Commonwealth Edison

January 28, 1985

Subject: Byron Generating Station Units 1 and 2
Braidwood Generating Station Units 1 and 2
Control Room Pressurization
NRC Docket Nos. 50-454/455 and 50-456/457

This letter is to inform the NRC of changes to the Byron/Braidwood control room HVAC systems and to propose appropriate revisions to the Technical Specifications. NRC review of these changes is necessary to finalize the Technical Specifications which will be incorporated into the Byron 1 full power operating license.

UPPER CABLE SPREADING ROOM
EL. 463'-5"

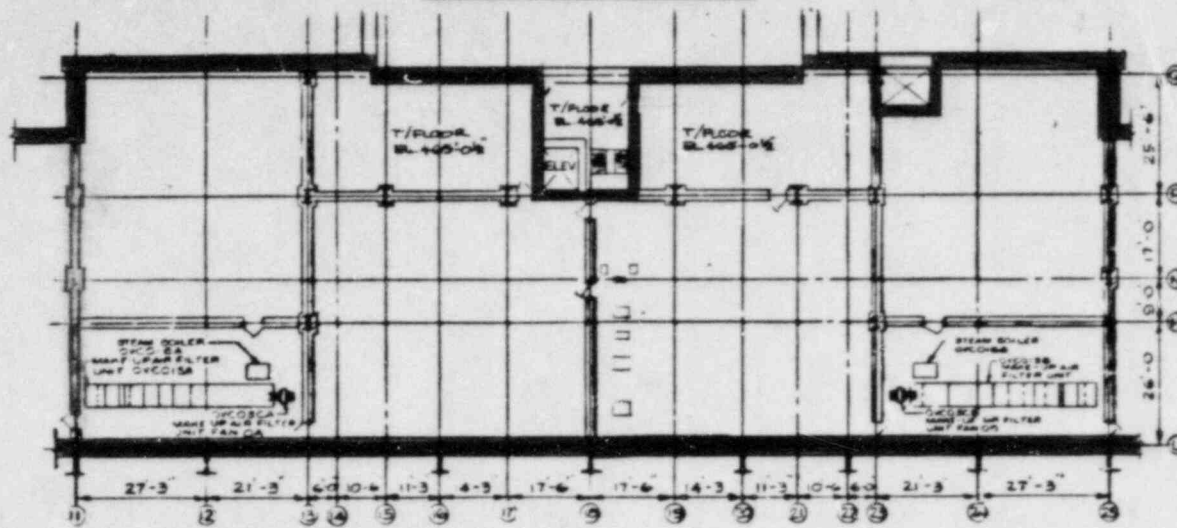
The upper cable spreading rooms will remain as part of the control room envelope, however, on a temporary basis this area will be maintained at a slight positive pressure. This will allow the installation of Unit 2 cables to proceed without delay. A reduction in the positive pressure in the upper cable spreading rooms will not threaten plant safety. Fire protection research has shown that small differential pressures will eliminate air inflow through large openings such as doors. This is discussed in more detail in Attachment A to this letter. To assure that there is no infiltration into the upper cable spreading rooms during Unit 2 construction, the pressure of these areas will be maintained at least 0.02" w.g. above the adjacent auxiliary building and turbine building areas. The appropriate revised pages for the Technical Specifications are provided in Attachment B.

1. The Control Room complex on elevation 451'-0" will be maintained at an average positive pressure of 0.125" WC.
2. The Upper Cable Spreading Room on elevation 463'-5" will be maintained at an average positive pressure of approximately 0.02" WC.

The design of the Control Room HVAC System is such that all air supplied to the Upper Cable Spreading Room is expended in pressurization. There is no return air from the upper cable spreading room to the system. In the unlikely event that any contaminants migrate into the upper cable spreading room and are induced into the return ductwork, this air will be passed through the 90% efficient recirculation charcoal adsorber before re-entering the Control Room Envelope.

LOWER CABLE SPREADING ROOM
EL. 439'-0"

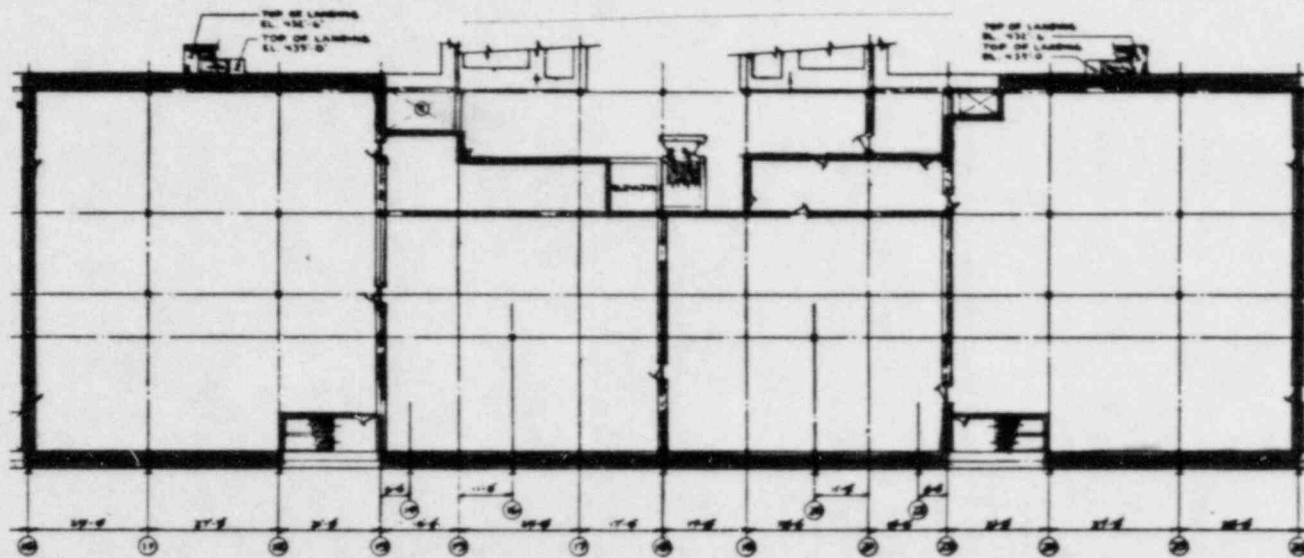
The lower cable spreading rooms will no longer be ventilated by the control room HVAC systems. The connecting ducts will be blanked off or removed. Without air conditioning the temperatures in these rooms may be slightly higher. Our calculations indicate it could be as high as 106.5°F in the limiting design basis situation. This will not pose an environmental qualification problem for any of the components (principally cable) in this area. The temperature limit imposed in Table 3.7-6 of the Byron Technical Specifications should therefore be revised from 90°F to 108°F. An appropriately

During our meeting with the NRC in Bethesda on December 18, 1984, it was agreed that in order to improve the ability of the Control Room HVAC System to pressurize the Control Room Envelope, the Lower Cable Spreading Room was deleted from the Control Room Envelope (reducing the Control Room volume by approximately 1/3 and increasing the air available for pressurization by approximately 22%), in addition, the local area exhaust from the toilet, storage and locker rooms and kitchen was removed and replaced with odor absorbing recirculation units (increasing the air available for pressurization by approximately 17%). This represented a combined increase of approximately 39% in air available for

pressurization. The supply duct to the lower cable spreading room and the exhaust fan discharge ducts were blanked-off. This resulted in an average control room pressure of 0.18" WC (Table 1, Item D).
